**Dewey-Burdock Project
Application for NRC
Uranium Recovery License
Fall River and Custer Counties,
South Dakota**

Technical Report RAI Responses

June 2011

Figure 2.6-1

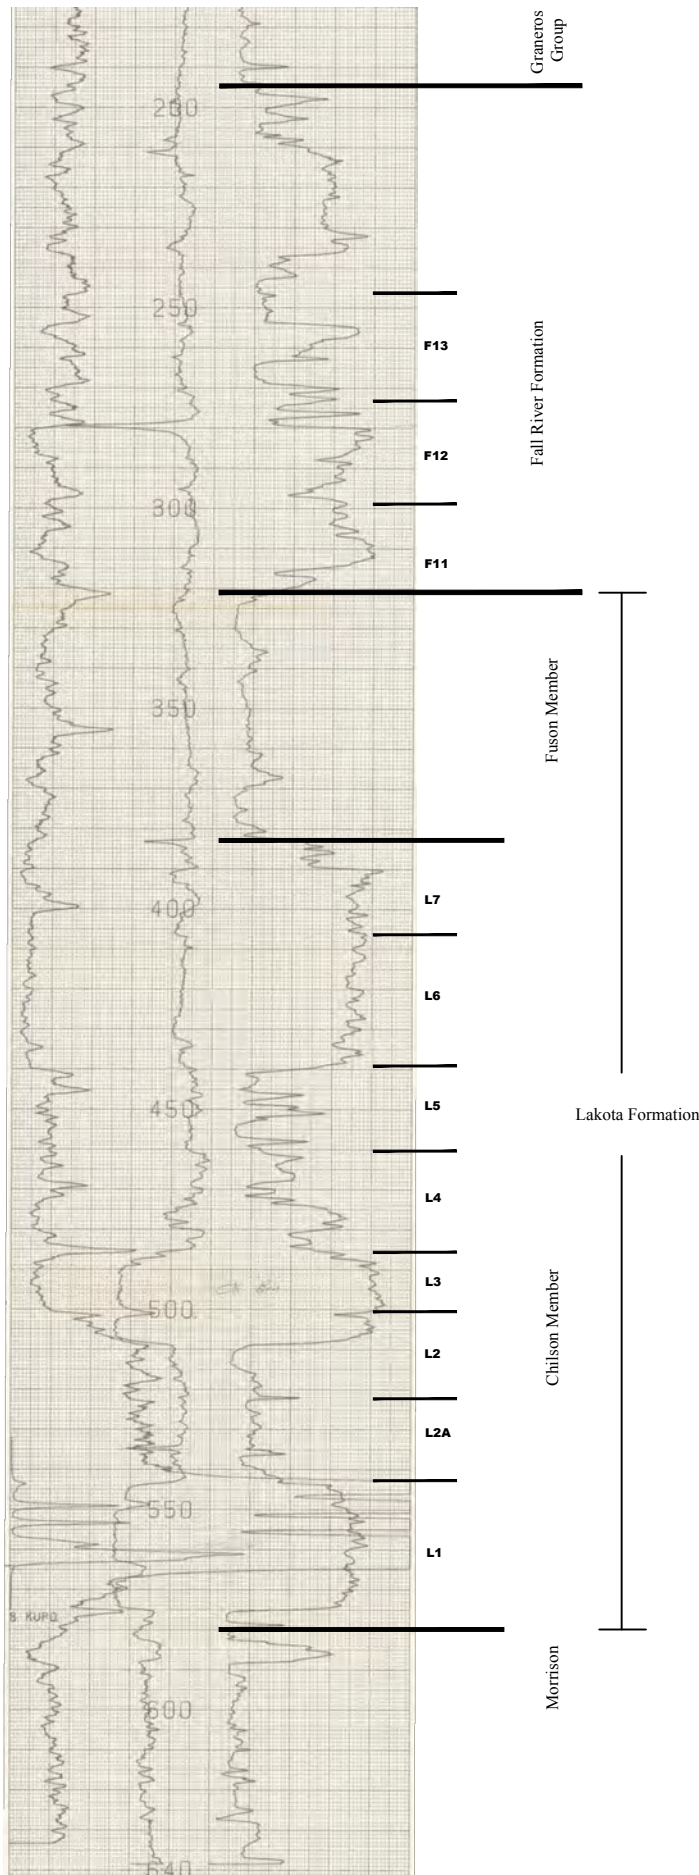
In this RAI, NRC staff questioned the ore body designations provided in Plate 2.6-1 of the TR. The “Typical Log” illustrated in TR Plate 2.6-1 is a single, good quality drill hole log, with the purpose of presenting the overall, general stratigraphy and the relative position of stacked ore bodies (roll fronts) within the entire Dewey-Burdock project area. This log does not precisely represent the stratigraphy within all potential well fields across the project. Plate 2.6-1 has been replaced with Figure 2.6-1, which clearly shows that there are no ore bodies within the Fuson Shale. The Fuson Shale is a confining unit, and uranium recovery will not and cannot occur within this unit. Figure 2.6-1 is included below and will be incorporated into the revised TR.

Figure TR RAI P&R-2-3

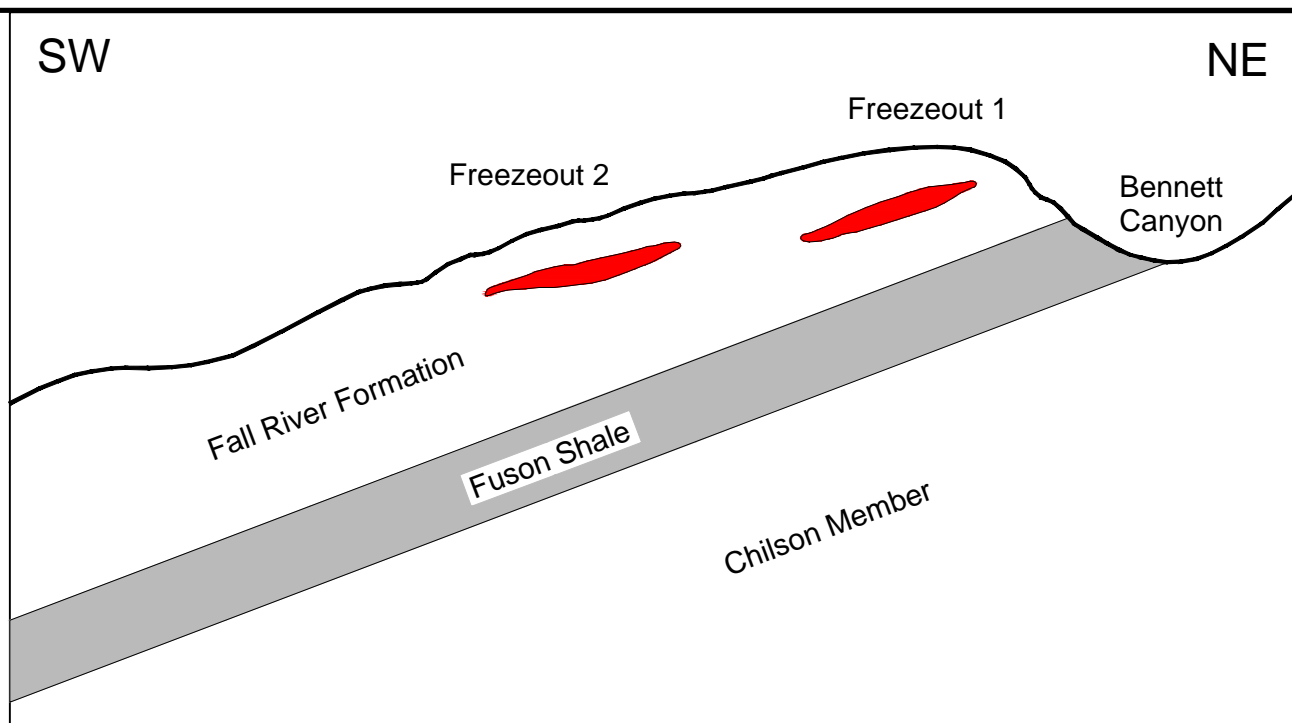
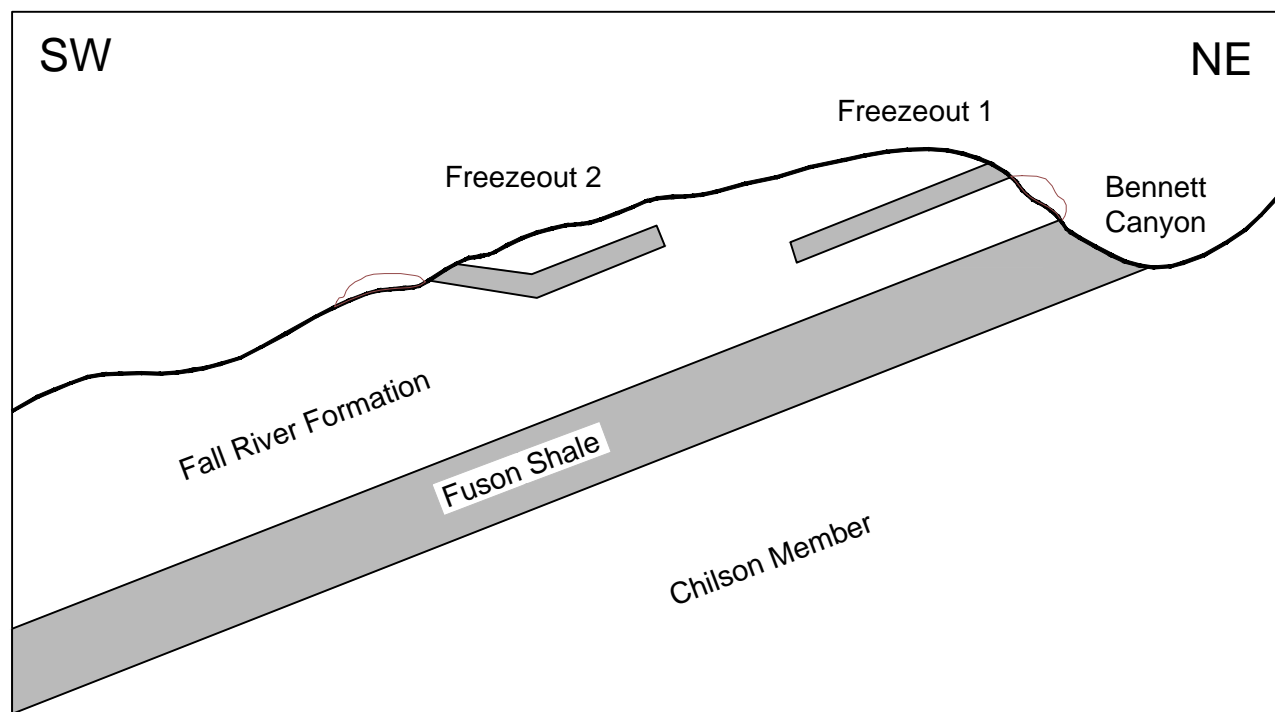
Needed: Please provide sufficient information concerning former and active oil and gas wells potentially at or near the Dewey-Burdock project and indicate whether there are any known underground mine workings at or near the project.

Figure TR RAI P&R-2-3, Type Log, Triangle Mine, is an electric log from an historical exploration drill hole located approximately 200 feet north of the mined area. The gamma activity shown in the type log corroborates the portion of the Fall River sand that was mined in the Triangle Mine and its position relative to the Fuson Shale confining unit. The top of the mineralized sand unit in the type log is at a depth of 125 feet below ground surface. The single mineralized front present within this sand unit correlates to Powertech's F13 interval, which is the upper mineralized zone within the Lower Fall River sand, the bottom of which is approximately 45 feet above the Fuson Shale. All mining took place well above the Fuson Shale, which averages 50 feet thick in this area. Accordingly these historic mining operations did nothing to compromise the integrity of the Fuson Shale confining unit.

Figure 3.2-4

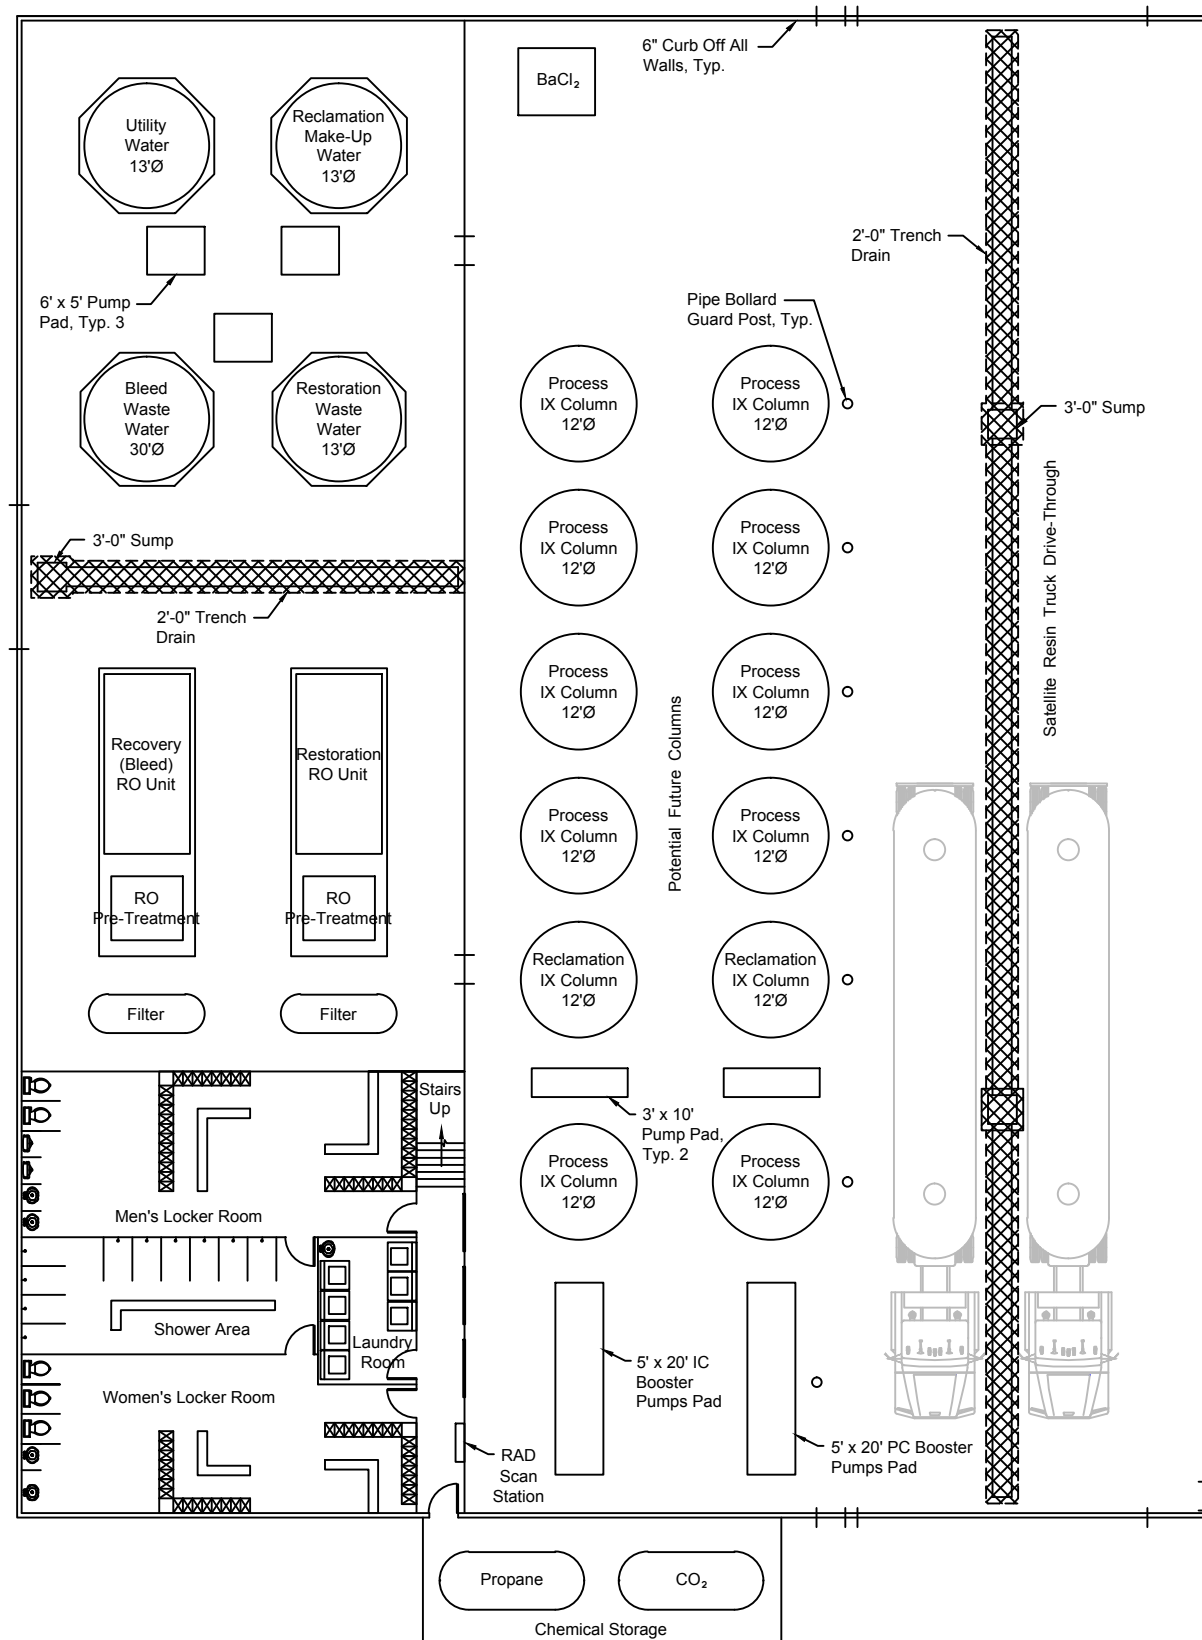
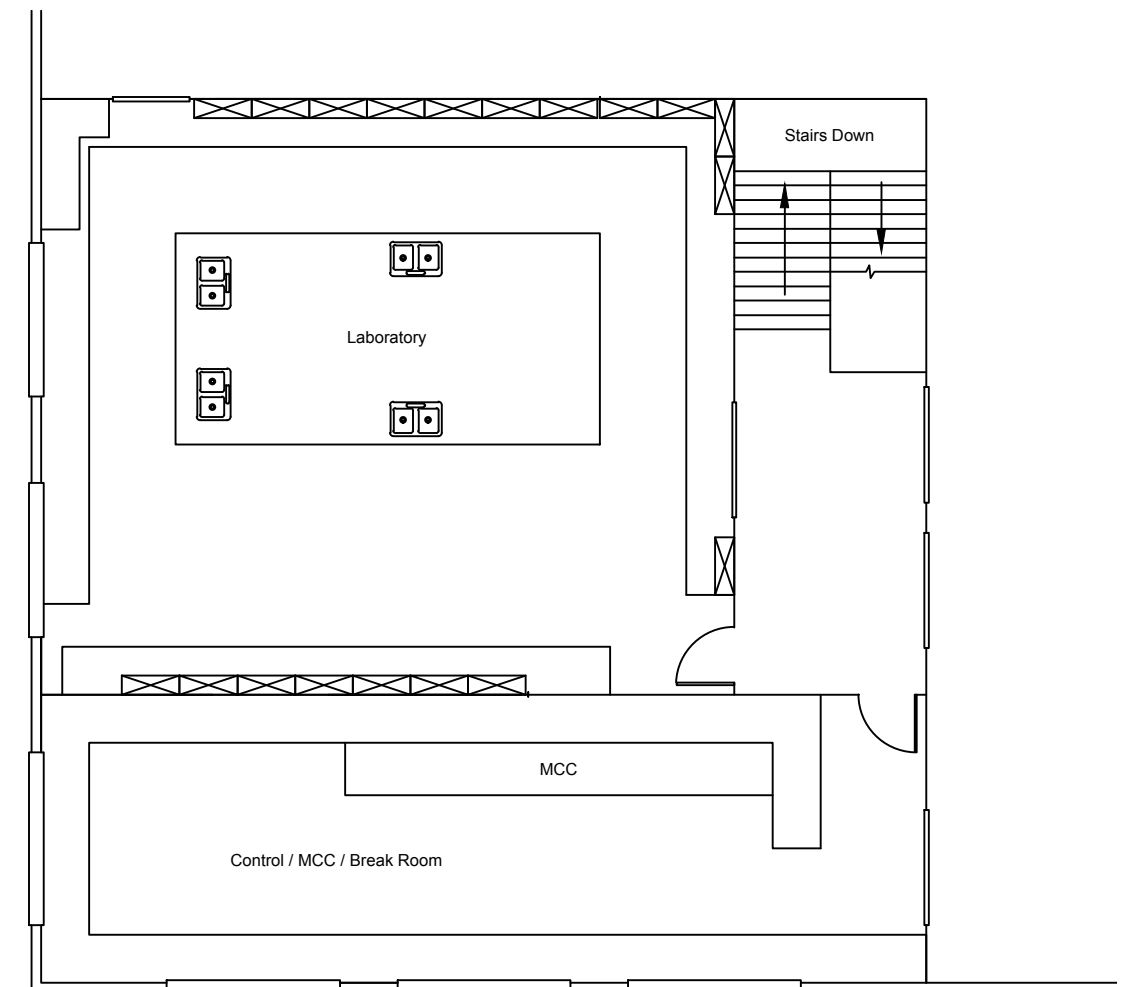
- b. The applicant needs to completely and clearly identify on Figures 3.2-4 and 3.2-5 the storage locations of all chemicals used in uranium processing (enlarge figure to be readable). The locations need to be consistent with the descriptions of chemical use provided in Section 3.2.8 of the application.***

TR Figures 3.2-4 and 3.2-5 have been revised and enlarged to show the storage locations of all chemicals used in uranium processing, with the exception of oxygen. The revised figures are included with this response package and also will be included in the revised TR. For a list of chemicals, refer to Table TR RAI MI-1a-1 provided in the response to TR RAI MI-1(a). Barium chloride will be stored as palletized sacks at the locations shown on Figures 3.2-4 and 3.2-5. Oxygen will be stored as cryogenic liquid in tanks located in the well field areas. Oxygen storage tanks will be located near but at a safe distance from header houses as required by NFPA and OSHA standards. Figures TR RAI MI-1b-1 and TR RAI MI-1b-2 depict the potential oxygen storage tank locations for the Burdock and Dewey initial well fields, respectively. Please refer to the response to TR RAI MI-1(a) for additional information about the safe storage of oxygen.

The acid storage tank will be located outside the CPP as shown in updated Figure 3.2-4, which has been revised and enlarged to indicate clearly the acid storage tank location. This figure is provided with the response to TR RAI MI-1(b). The acid storage tank will be vented directly to the atmosphere and not through the roof of the CPP. TR Section 3.2.8 will be revised to correct this inconsistency by noting that the acid tank will be vented directly to the atmosphere.
